SUBJECT: NuScale Power, LLC Response to NRC Request for Additional Information No. 9172 (eRAI No. 9172) on the NuScale Topical Report, "Evaluation Methodology for Stability Analysis of the NuScale Power Module," TR-0516-49417, Revision 0

Response to Request for Additional Information Docket: PROJ0769

eRAI No.: 9172

NRC Question No.: 01-59

Figure 1: Diagram of the CVCS

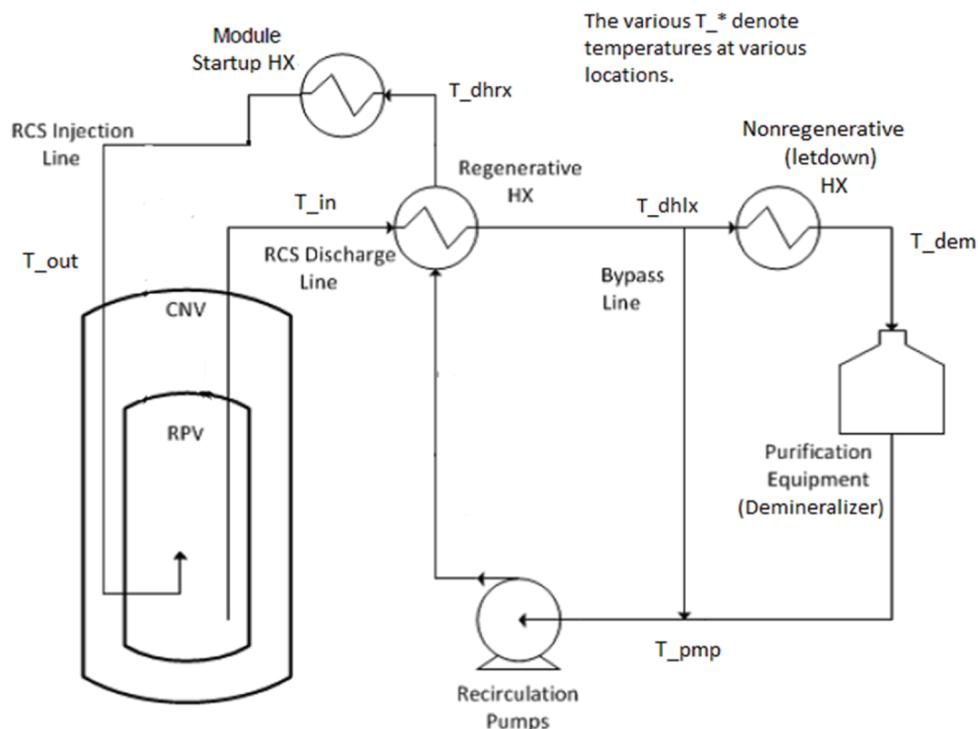
In order to make an affirmative finding associated with the above regulatory requirement important to safety, NuScale should provide a detailed description of the CVCS model in PIM that includes: a list of the components of the CVCS, a flow diagram, and equations describing how flow rates and fluid temperature are computed by PIM.

The NuScale chemical volume and control system (CVCS) is simple in design and is not required to function during or after an accident. During normal operation, the CVCS recirculates a portion of the primary coolant through demineralizers and filters to maintain primary coolant cleanliness and chemistry. A portion of the recirculated coolant is used to supply the pressurizer sprays for controlling reactor pressure. Primary system coolant inventory is controlled by injection of additional water when the primary coolant levels are low or letdown of primary coolant to the liquid radioactive waste system when coolant inventory is high. Additionally, during the module start-up process, the CVCS is used to add heat to the primary coolant via the module heatup heat exchanger to establish natural circulation flow in the primary coolant system. A diagram of the CVCS is provided in Figure 1.

Relative to Figure 1, PIM has the following simplifications regarding the CVCS.

In PIM, the CVCS is modeled by withdrawing letdown at a user-specified flow rate from a user-specified node in the downcomer at the local node conditions, passing the extracted fluid through the CVCS heat exchangers and pumps, and returning charging flow to a user-specified node in the riser. The fluid mass and energy are added to the node via calculations within PIM. No credit for the momentum transfer from the injected flow is taken that might increase the primary loop flow. Letdown flow and charging flow are each lagged by 10 seconds to represent the delaying effects of flow through long pipes.

The CVCS model in PIM is discussed more below. The variables used in the discussion below are listed in Table 1, which relates the variables to locations of Figure 1. Enthalpies and temperatures are related via a state call that assumes subcooled liquid at the RCS pressure.
